Form 3160-5
(June 2019)UNITED STATES
DEPARTMENT OF THE INTERIOR
BUREAU OF LAND MANAGEMENTFORM APPROVED
OMB No. 1004-0137
Expires: October 31, 2021**SUNDRY NOTICES AND REPORTS ON WELLS**
Do not use this form for proposals to drill or to re-enter an abandoned well. Use Form 3160-3 (APD) for such proposals.

8. Well Name and No. HAWK 35 FED/403H

EOG respectfully requests an amendment to our approved APD for this well to reflect the following changes:

Hawk 35 Fed 511H (FKA 403H) API #: 30-025-48032

WELL LOCATION AND ACREAGE DEDICATION PLAT

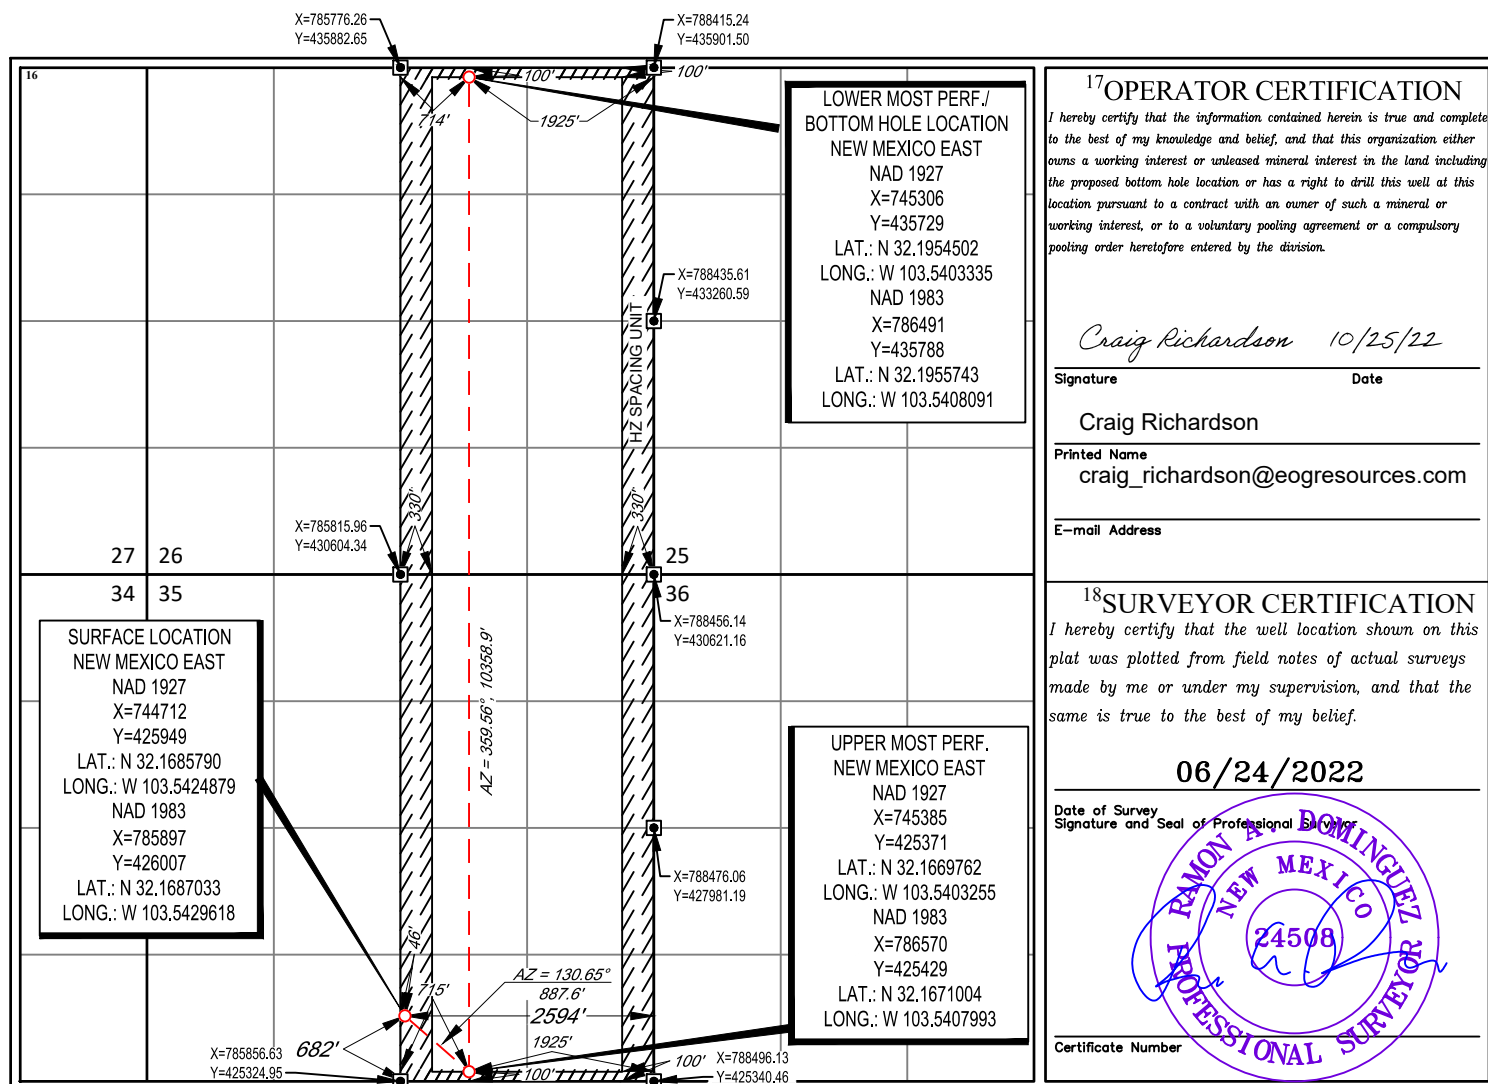
EOG respectfully requests an amendment to our approved APD for this well to reflect the following changes:

Change name from Hawk 35 Fed 403H to Hawk 35 Fed 511H.

Change BHL from T-24-S, R-33-E, Sec 26, 100' FNL, 1980' FWL, Lea Co., NM,
to T-24-S, R-33-E, Sec 26, 100' FNL, 1925' FEL, Lea Co., N.M.

Change target formation to Second Bone Spring Sand.

UL or lot no.	Section	Township	Range	Lot Idn	Feet from the	North/South line	Feet from the	East/West line	County
B	26	24-S	33-E	—	100'	NORTH	1925'	EAST	LEA
